### SUBJECT: Audit of PG&E's Implementation of their Enhanced Vegetation Management Program in 2020

Audit Report on PG&E's Implementation of their Enhanced Vegetation Management Program in 2020

February 8, 2021

Figure 2. Miles Completed and Unworked Miles, Top 20 Circuits (September Model Rankings)<sup>13</sup>

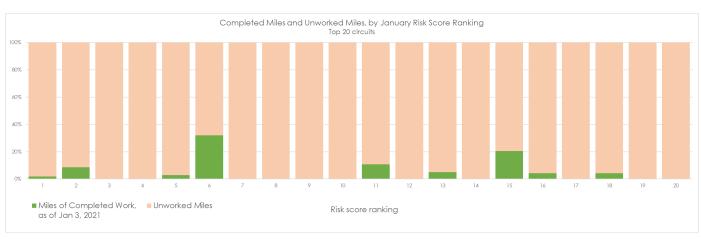
Furthermore, the WSD would expect to see a substantial proportion of the total miles for the highest risk circuits prioritized in PG&E's EVM work. However, this observation was not found in the data provided. As shown in Figure 2 for the top 20 circuits in the September model, and in Figure 3 for the top 20 circuits in the January model, a significant proportion of the total miles for these high priority circuits remains unworked.

Of the Top 20 ranked circuits from the September model shown above, the average percentage of completed work miles over "HFTD Miles from KPMG" cited in the January model (equivalent to "Tier 2/3 OH Miles" cited in the September model) is 4.2%.

Figure 4. Miles Completed and Unworked Miles, 161 Circuits with Work Performed in 2020, September Risk Score Rankings<sup>14</sup>

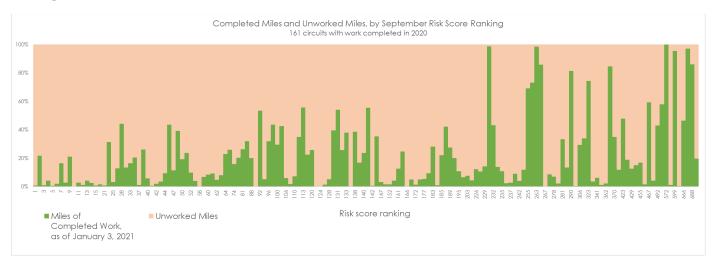
Looking at the full set of 161 circuits for which work was performed in 2020, the low prioritization of the highest risk circuits is notable. See Figure 4 below for the miles completed vs. miles unworked for all 161 circuits ranked by September risk score from left to right with work completed in 2020. Figure 5 below shows the miles completed in 2020 vs. miles unworked for all 161 circuits ranked by January risk score from left to right.

Figure 5. Miles Completed and Unworked Miles, 161 Circuits with Work Performed in 2020, January Risk Score Rankings<sup>15</sup>

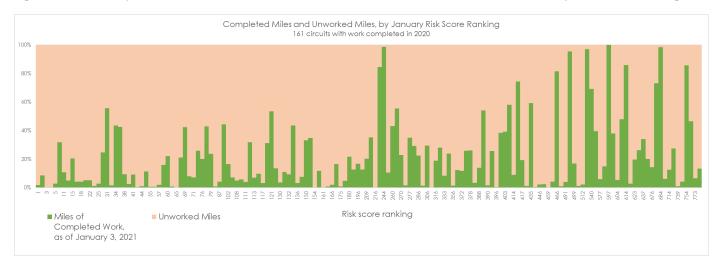
By performing incomplete EVM on the circuits identified as highest risk and allocating resources instead to conducting EVM on lower risk circuits, PG&E is not reducing risk as planned in its WMP.

Figure 6. Narrows 1101 defect

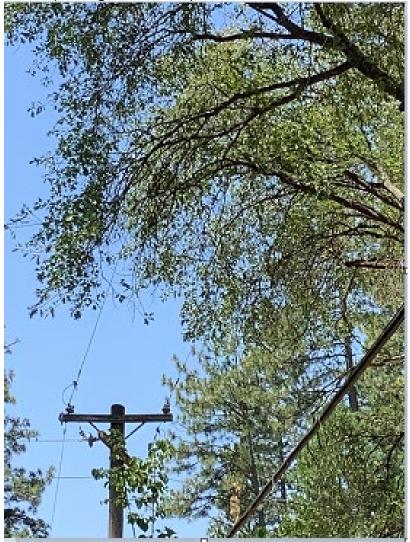
The Narrows 1101 circuit has one open, severe defect:

1. QA/QC results show poor performance of the current vegetation management program. (see Figure 6 below).
